# UNITED STATES PATENT AND TRADEMARK OFFICE

APPLICATION NO.	FILING DATE	FIRST NAMED INVENTOR	ATTORNEY DOCKET NO.	CONFIRMATION NO.
10/700,512	11/05/2003	Pushpito Kumar Ghosh	3095-009	5938

### Office Action Summary

### **DETAILED ACTION**

U.S. Patent

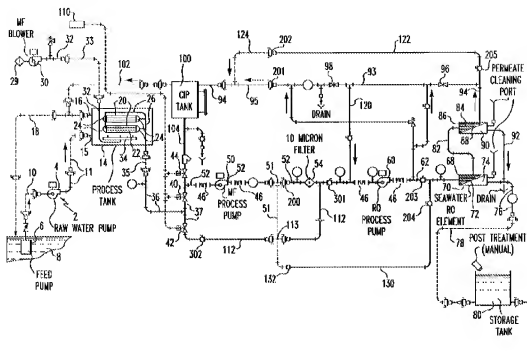
Daly teaches a reverse osmosis system with prefilter (20), reverse osmosis membranes (70,84), process tank, pumps, several solenoid valves, recirculation of the retentate water (through lines 93-93-120), back pressure regulator (see drain line or the recirculation line to the CIP tank: reverse osmosis systems require a back-pressure regulator to maintain the high pressure over the membrane for the separation to happen, and it is implied in the system if not explicitly stated). See the figure reproduced below.
